Office Action Summary

10/687,811

ONO ET AL.

Fig. 2

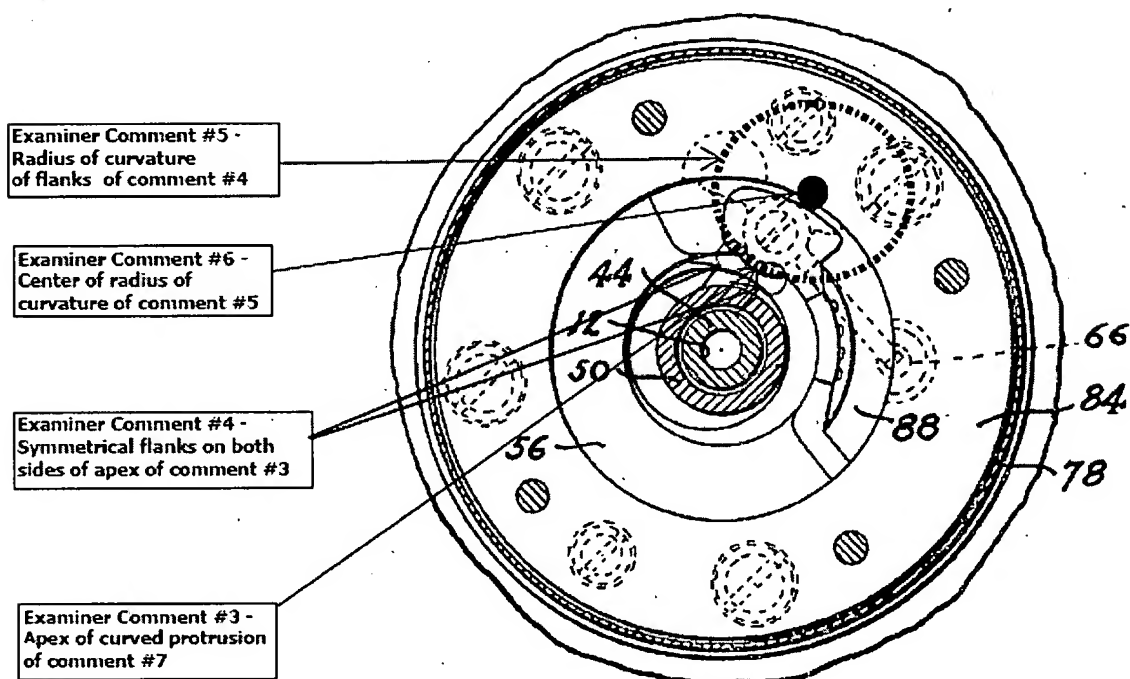
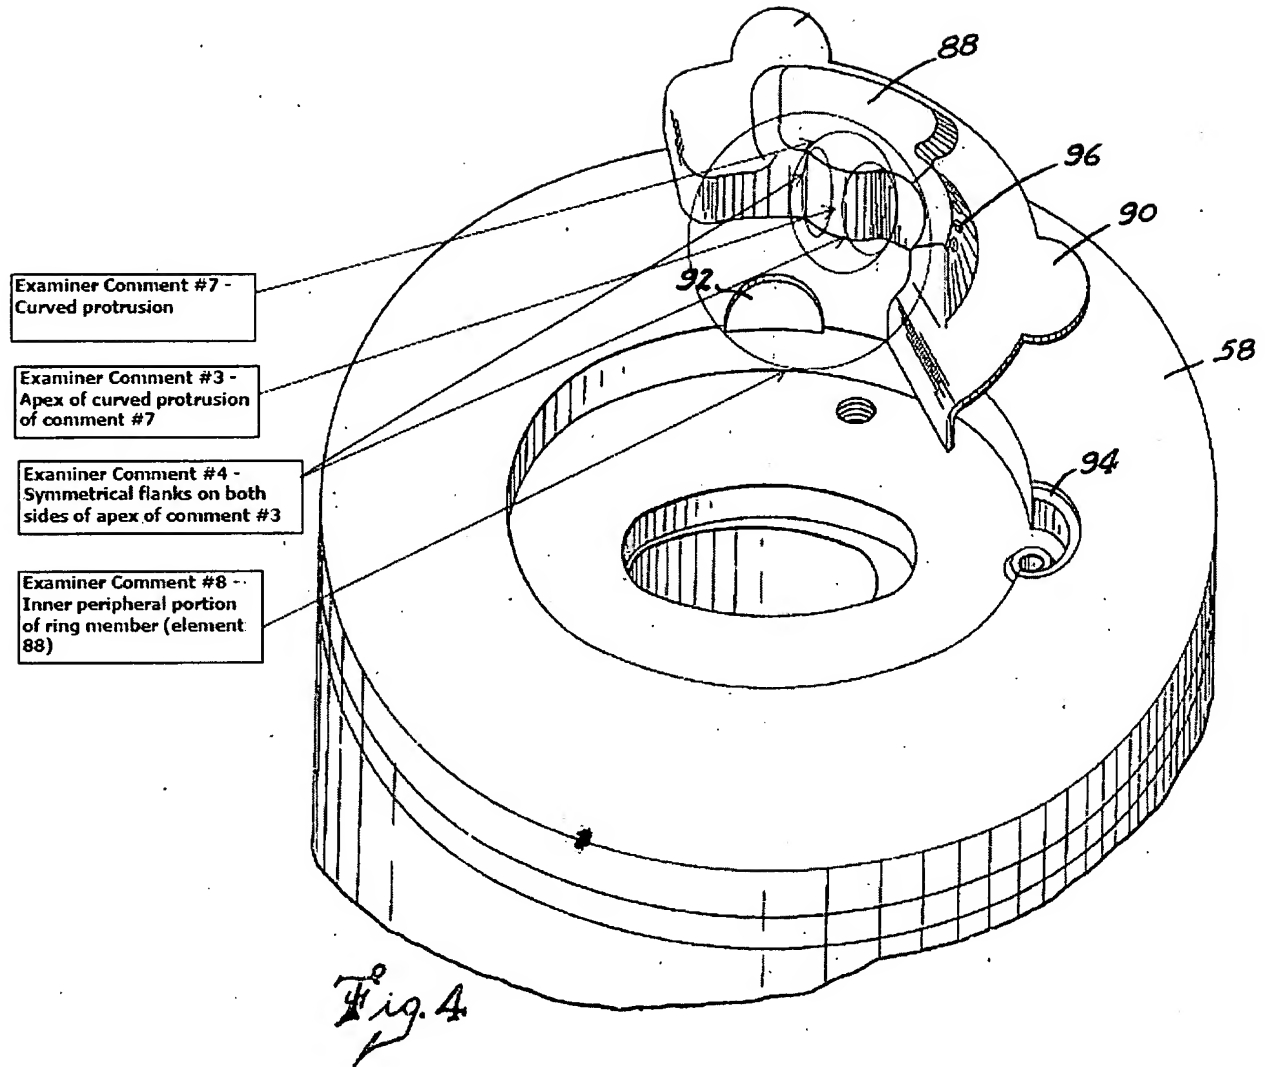
6. Claims 14-17, 19-20, 22-24, 26-27, and 29 rejected under 35 U.S.C. 103(a) as being unpatentable over Park JP - 2001248555, reference numbers herein taken from the US patent Park US 6,422,833, in view of Tarlton US 2,141,053. Park teaches all the limitations as discussed but fails to teach the following limitations for a compressor that are taught by Tarlton: (claim 14) a curved protrusion (fig. 4 – examiner comment 7) having an apex (fig. 2 and 4 – examiner comment 3) and flanks (fig. 2 and 4 – examiner comment 4) on opposite sides of said apex, with said flanks (fig. 2 and 4 – examiner comment 4) each have a radius of curvature (fig. 2 – examiner comment 5) such that a center (fig. 2 – examiner comment 6) of the radius of curvature is positioned outside of said cup-shaped stopper 74; (claims 15 and 22)

further in figures 2 and 4, Tarlton teaches flanks that are generally symmetrical relative to one another about an apex (fig. 2 and 4 – examiner comment 3); (claims 16, 19, 23, 26) a cup-shaped stopper 74 comprises a ring member 88, and said curved protrusion (fig. 2 and 4 – examiner comment 7) is formed by deforming an outer peripheral portion (fig. 4 – examiner comment 8) of said ring member 88 such that a resulting deformation of an inner peripheral portion of said ring member corresponds to said curved protrusion (fig. 2 and 4 – examiner comment 7); (claims 17, 20, 24, 27, 29) and figure 4 teaches a curved protrusion (fig. 2 and 4 – examiner comment 3) that extends along an axial direction of said cup-shaped stopper 74. It would have been obvious to one of ordinary skill in the art to modify a stopper to have an apex and flanks extending along an axial direction of a crankshaft in order to provide a shielding protrusion helps provide a quiet operation and reduction in wear to components (Tarlton – pg. 1 col. 1 ll. 41-48).

A copy of the figures with reference to Tarlton and the examiner's comments is provided on page following item 8 of this office action.

within said compressor chamber 60 in back and forth directions and a curved protrusion (fig. 4 – examiner comment 7) extends generally orthogonal to the back and forth directions. A combination of Park and Tarlton would teach the limitation of a curved protrusion extending in a direction orthogonal to a back and forth motion of a reciprocating piston. Suzuki teaches a protrusion 117 formed in a cup shaped stopper 16 receiving a crankshaft 7, extending in a direction orthogonal to a back and forth motion of a piston 12 in a hermetically sealed compressor 1 for the purposes of reducing the occurrence of a compressor body shaking against an inner wall of a compressor casing (Suzuki – col. 1 ll. 70- col. 2 ll. 2). It would have been obvious to one having ordinary skill in the art at the time the invention was made to provide a protrusion in a stopper for a compressor to reduce the occurrence of a compressor body striking against an inner wall of a casing of compressor in order to prevent damage to a compressor during normal operation (Suzuki – col. 1 ll. 70- col. 2 ll. 2).
